Tonkin Park Stage II Bassendean

**Section 46(1) Report and recommendations
of the Environmental Protection Authority**

**Environmental Protection Authority
Perth, Western Australia
Bulletin 960
November 1999**

Assessment No.1201

Figure 5. Conceptual plan showing cross-section of on-site containment cell.

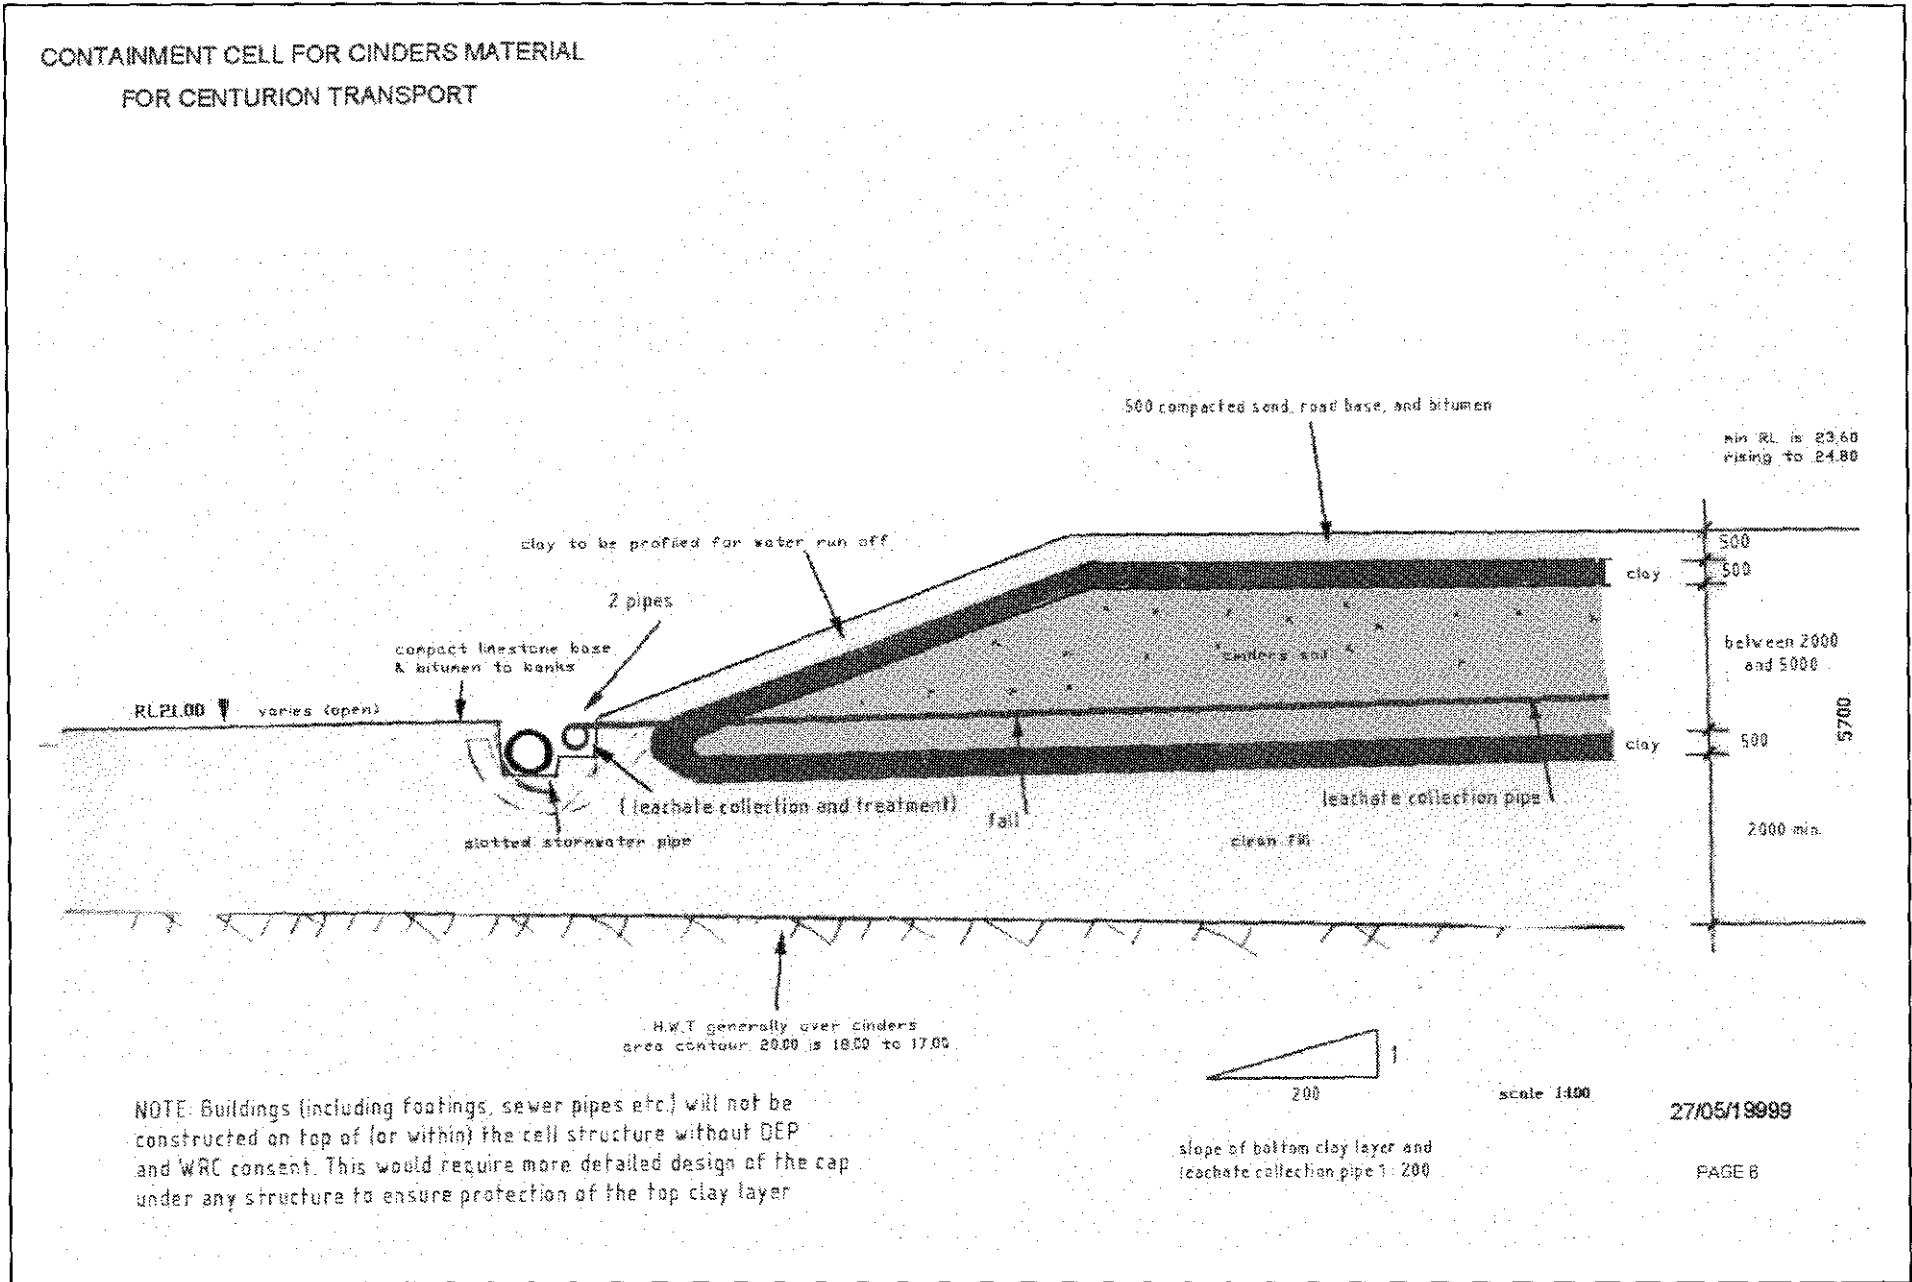
In response to public submissions on the Section 46 report, the proponent has modified the on-site containment cell design and has provided a conceptual plan (Figure 5) to ensure that the cell is designed and constructed for long term stability.

In summary, the EPA considers that containment of wastes within the modified cell design (Figure 5) is an acceptable option to manage the wastes on site and that approval of the final cell structure is subject to the proponent complying with recommended Environmental conditions 3, 4, 5, 6 and 8 (Appendix 7). Condition 3 relates to the remediation of the Stage II site, condition 4 requires the proponent to prepare a water quality management plan, condition 5 requires an Environmental Management Programme, condition 6 requires that the cell be designed and constructed to the requirements of the EPA as set out in schedule 5 of the draft Ministerial statement and condition 8 requires the proponent to commence the construction of the cell within 3 years of the date of the Ministerial statement.

The containment of the pyrites within a clay cell structure as proposed in the conceptual plan (Figure 5), will prevent any significant contact of water with the pyritic wastes. In addition, a leachate collection system will be incorporated into the cell design construction. This will allow on-going monitoring of the cell performance, early detection of cell leakage, and treatment and disposal of the leachate collected. The EPA notes the advice provided by the Water and Rivers Commission that "the contained waste is not considered likely to generate significant quantities of leachate once encapsulated" and "that monitoring the quality and quantity of water in the toe drain will indicate whether the containment cell is working effectively" (WRC letter, 1999).

Design component	Original design	Modified design
separation distance between the base of cell and the seasonal high water table	1 metre	2 metre
cell base	10cm limestone	50 cm compacted clay
vertical barriers or sides of cell	nil	50 cm compacted clay
cell cap	10cm limestone	50 cm compacted clay
leachate collection and treatment system	nil	yes
leachate monitoring facility	nil	yes
cap cover	mixture of bitumen, gravel, limestone	50 cm compacted clay and 1m sand, road base and bitumen.
neutralising wastes	yes	no - not required as containment design now minimises water intrusion and hence leachate generation.

Figure 6. Location of proposed truck loading terminal.

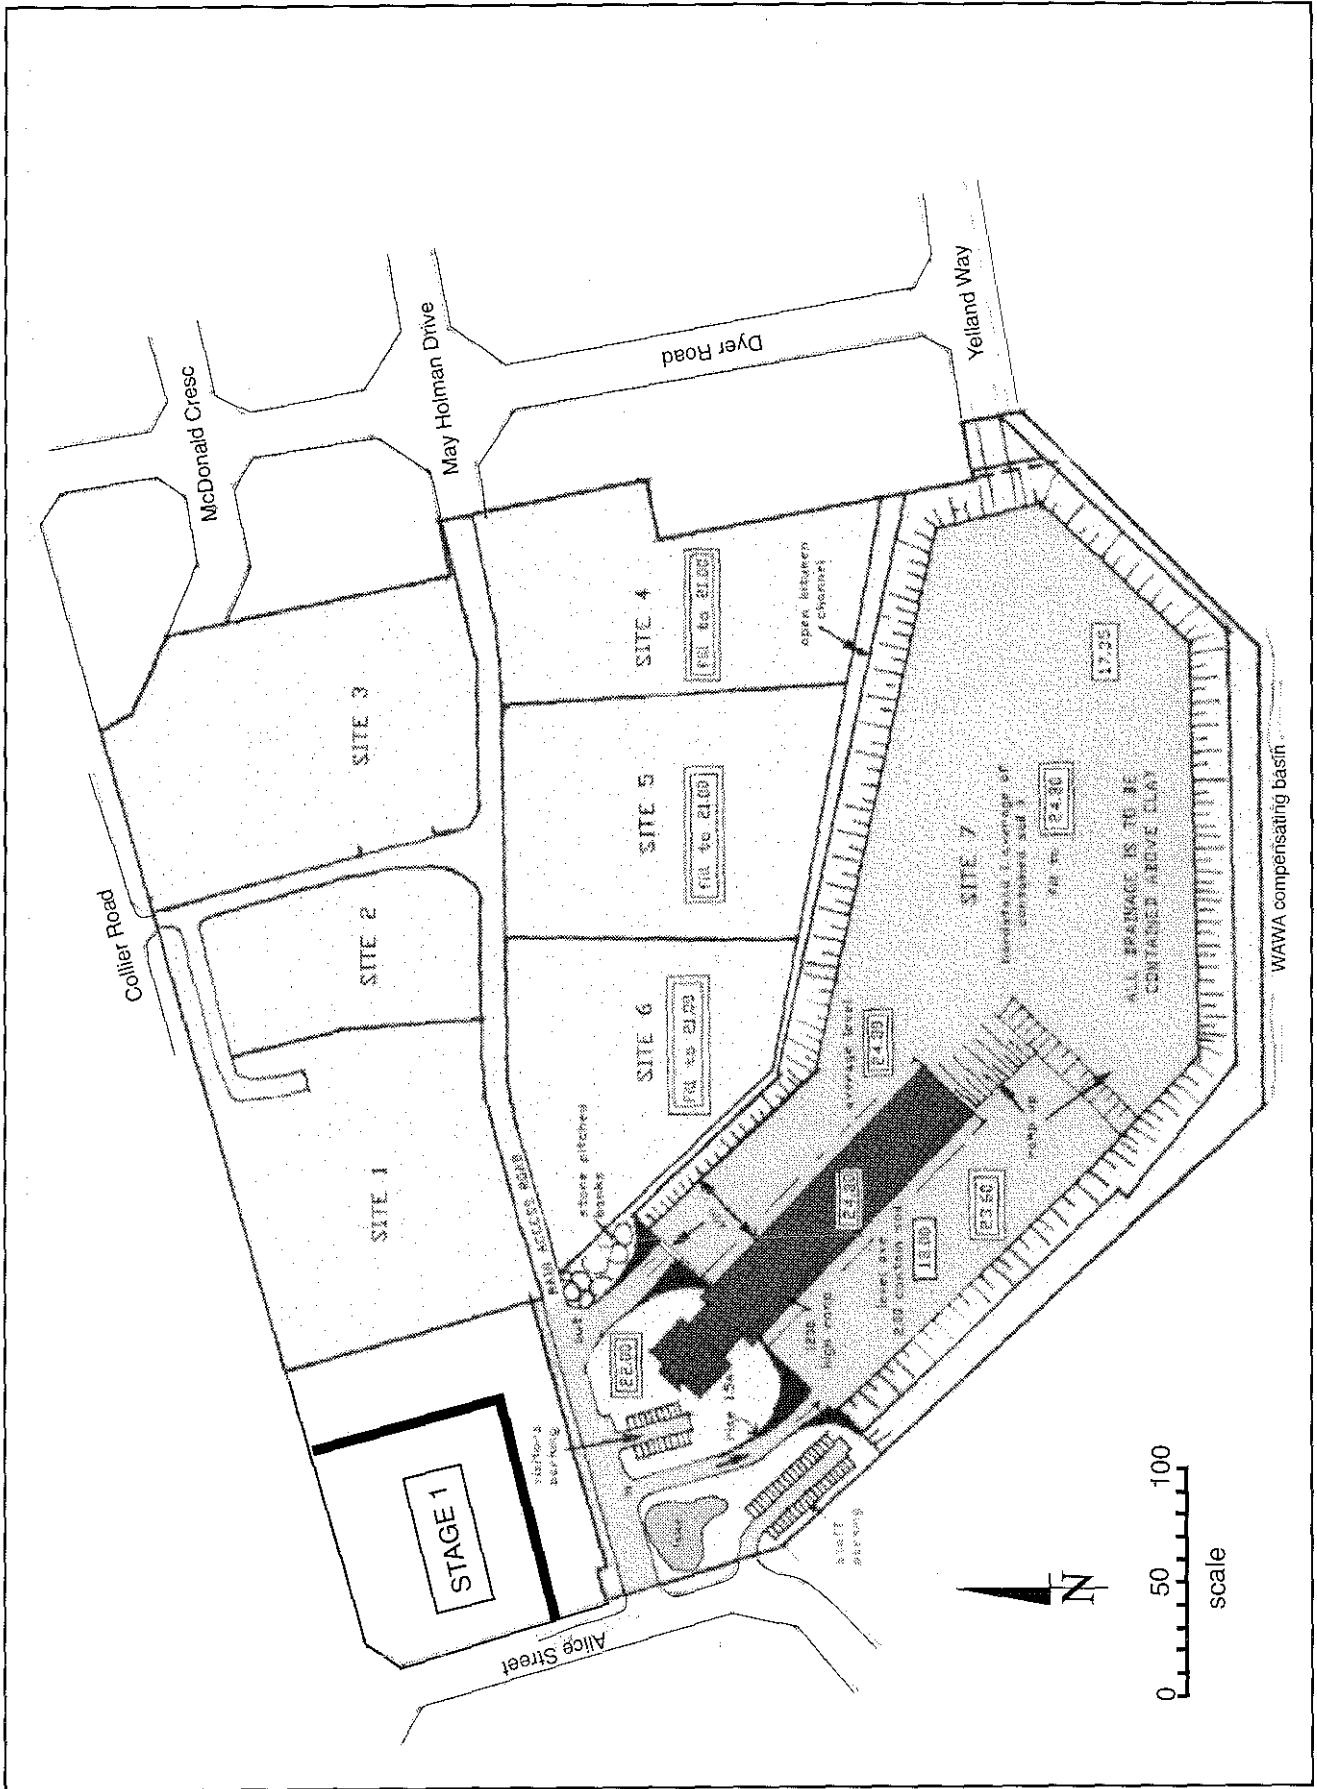
The proposed development on Stage II land, after remediation, would consist of a truck loading terminal which would have new warehousing, truck loading bays, roadways, and large bitumen-covered parking areas for road trains. Figure 6 shows a conceptual plan of the proposal.

The EPA considers that the proposed use of the site, particularly above the cell structure, as a truck terminal facility is acceptable subject to the proponent preparing a final detailed plan of the truck terminal facility to the requirements of the EPA and recommended Environmental conditions 6-6 to 6-9 being imposed on the proponent.

Figure 7. Direction of drainage flow to Swan River from Tonkin Park site.

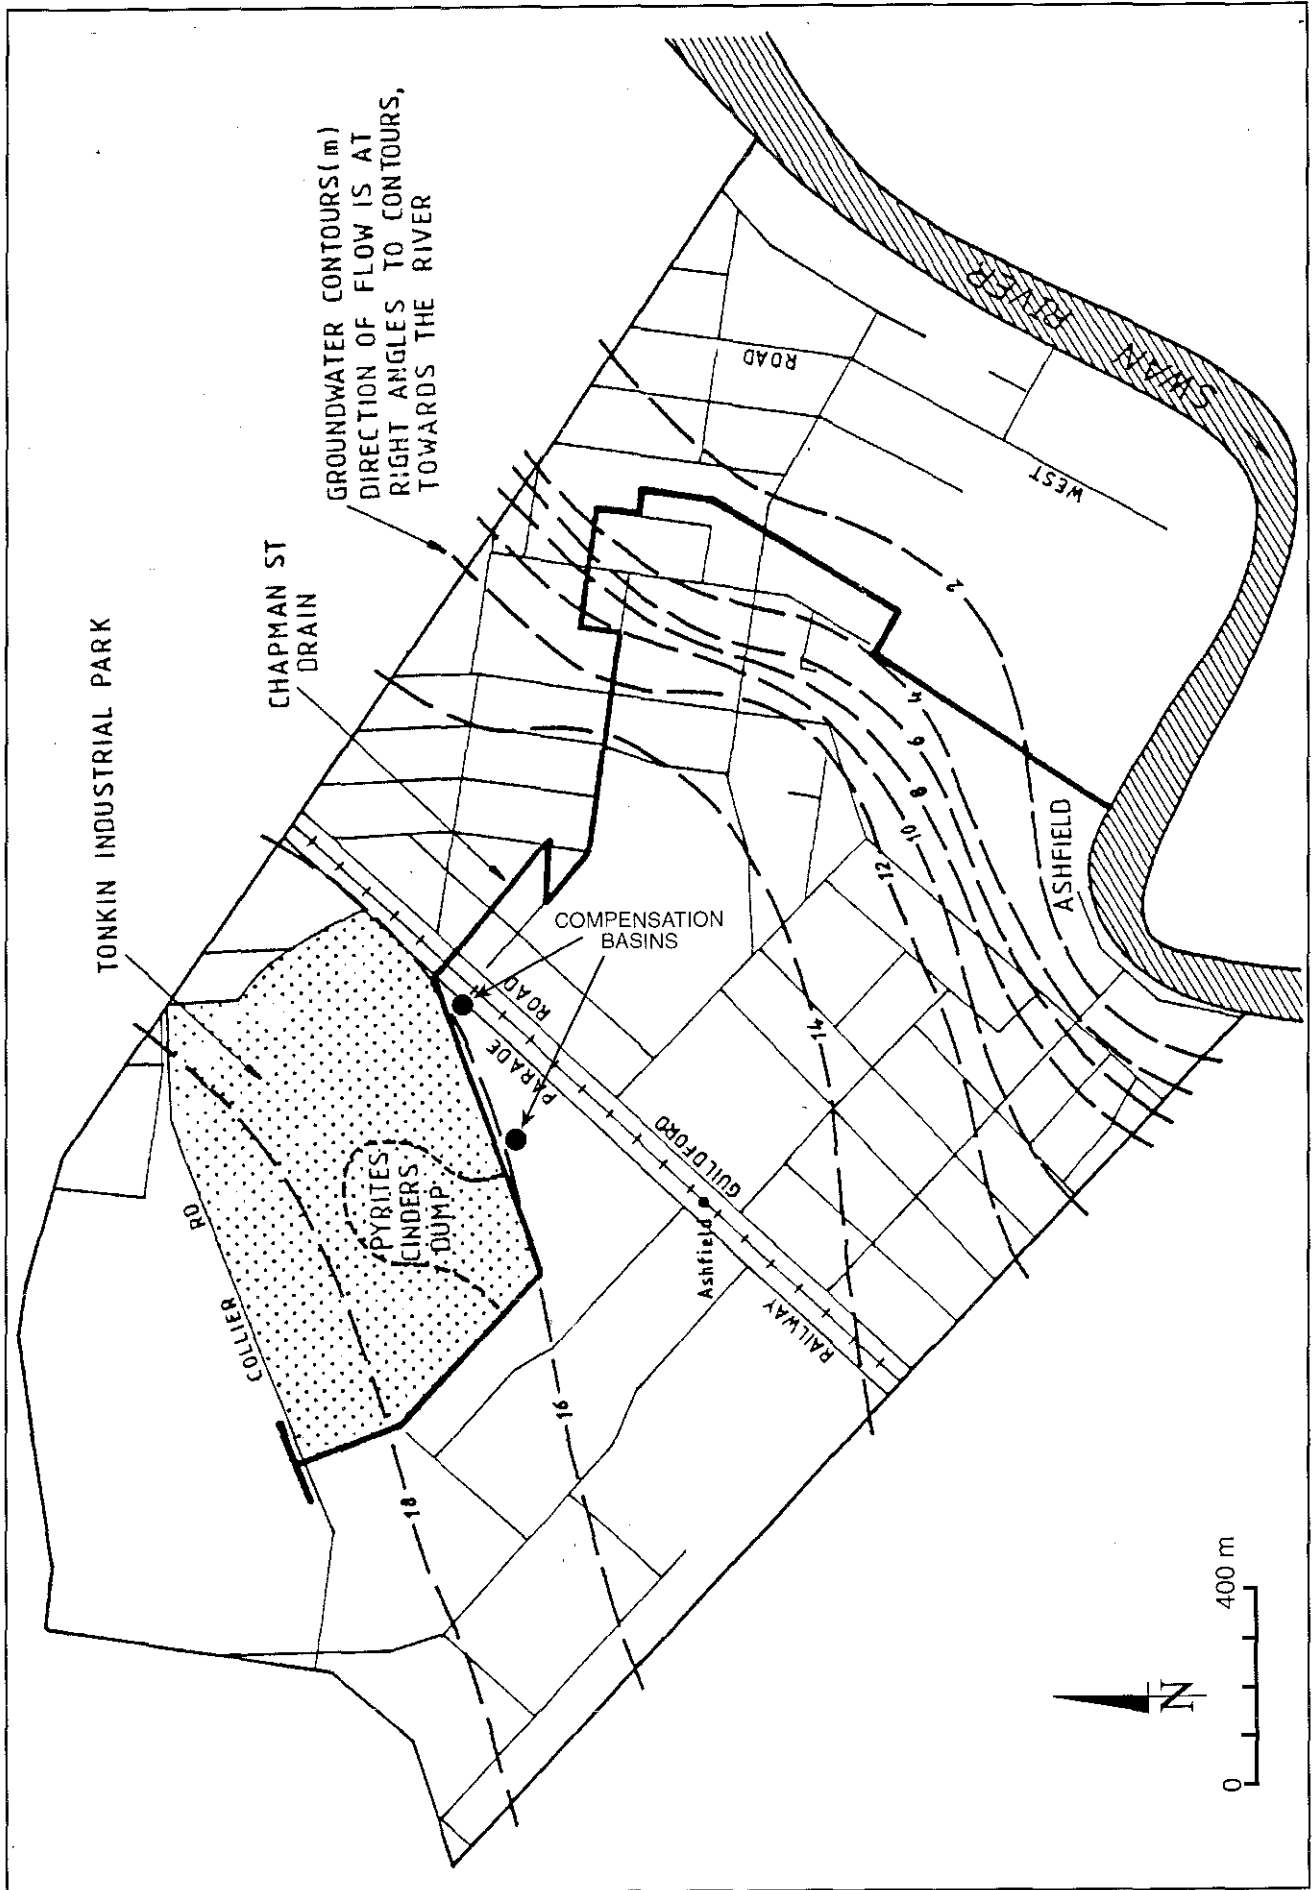
Additional comments were made regarding the contaminated sediments in the compensation basins adjoining the Tonkin Park Stage II site (Figure 7). It was suggested that the two compensation basins located in the south-east corner and external to the site boundary should be remediated to reduce impact on the Swan River. These basins are external to the Tonkin Park Stage II site and are not considered to be part of the project area. Therefore, the proponent is not required to remediate land outside the project area.
